Lycee Rochambeau – Rollingwood Campus, Mandatory Referral, MR2018007

Completed: 12/12/2017

- Mandatory Referral to add a 1,280 sf (32'x40') modular classroom;
- Current use: private school;
- Located at 3200 Woodbine Street in Chevy Chase;
- 4.07-acre site zoned R-90 in the *Bethesda-Chevy Chase Master Plan* area;
- Applicant: Rochambeau, the French International School on behalf of Montgomery County Public Schools; and
- Acceptance Date: Oct 26, 2017.

Figure 5: Pedestrian and Vehicle Circulation

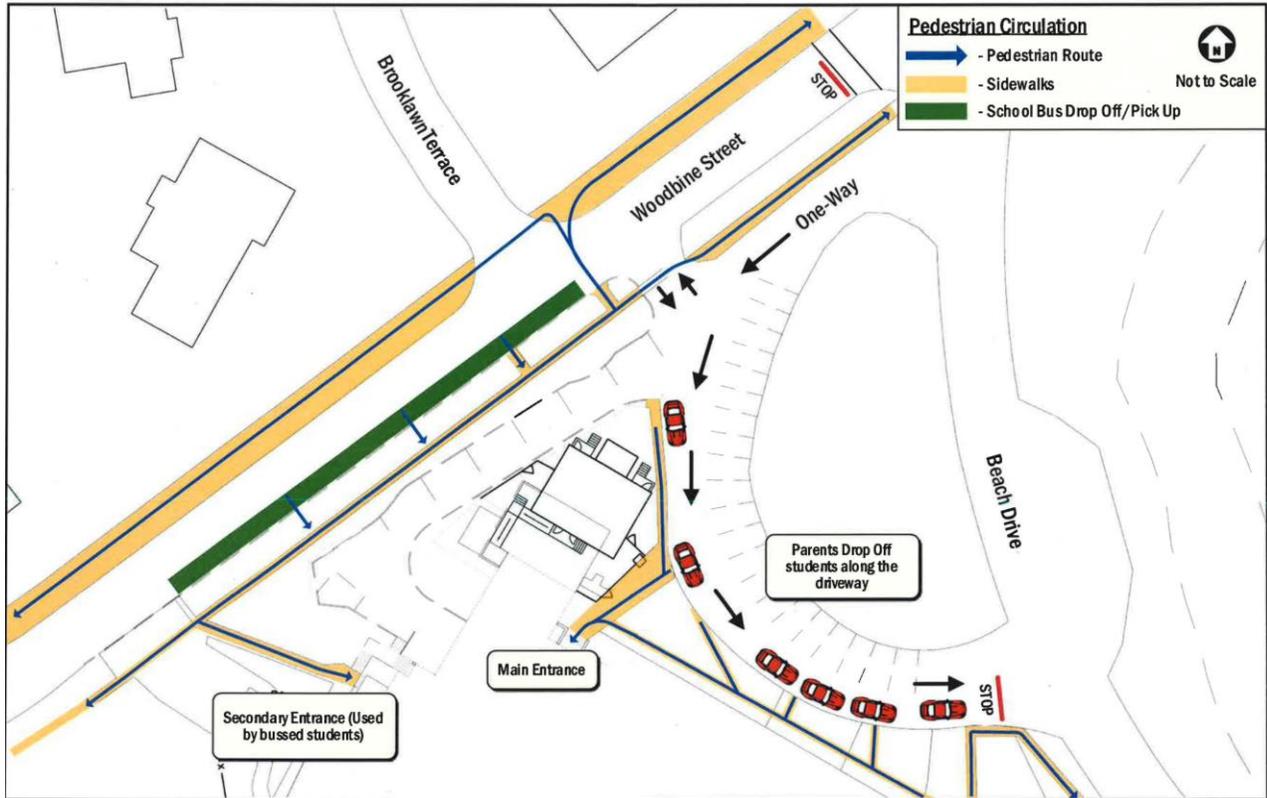
Access to the school is currently from Beach Drive and Woodbine Street. The two driveways along Beach Drive consist of a northern inbound only driveway and a southern outbound only driveway, which provides for a counter-clockwise in/out access loop for teacher and visiting vehicles circulating through the site. Visitors and teachers can also access the site from the full-movement driveway on Woodbine Street. Buses load and unload on Woodbine Street, on the south (school campus) side. Students disembarking from the buses access the school along sidewalks leading to a secondary, rear entrance. See Figure 5.

DATE: 11/29/2017
 PROJECT NO.: 2017-001
 DRAWING NO.: 1A
 CHECKED BY: DMC
 SHEET TITLE: SITE PLAN

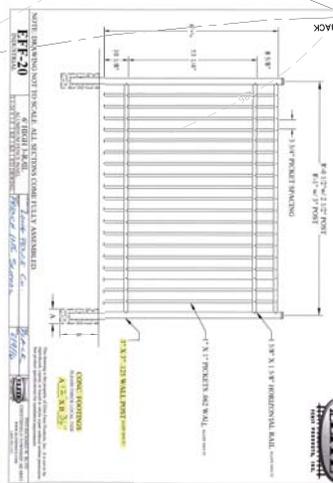
1. Any future improvements to the school must include a queuing and parking study if those improvements will increase the school's student core capacity beyond 350 students. Enrollment must be reported to the Montgomery County Public Schools (MCPS) Department of Schools Facilities annually as part of the renewed lease agreement with MCPS.
2. The queuing of cars on Beach Drive must be prohibited.
3. Provide trees along Woodbine Street and an ornamental fence as shown in the revised Site Plan (*Attachment B*).

In response to these concerns, Staff recommends the school strongly encourage parents to use of the designated onsite queue lane to reduce parking along Woodbine Street and Brooklawn Terrace. School communication should also emphasize the use of the school side of Woodbine Street for on-street parking to improve safety for the students and reduce impacts on the adjacent residences. In terms of visual impact, the Applicant has included additional screening measures with street trees along Woodbine Street and the ornamental fencing along the rear of the modular classroom.
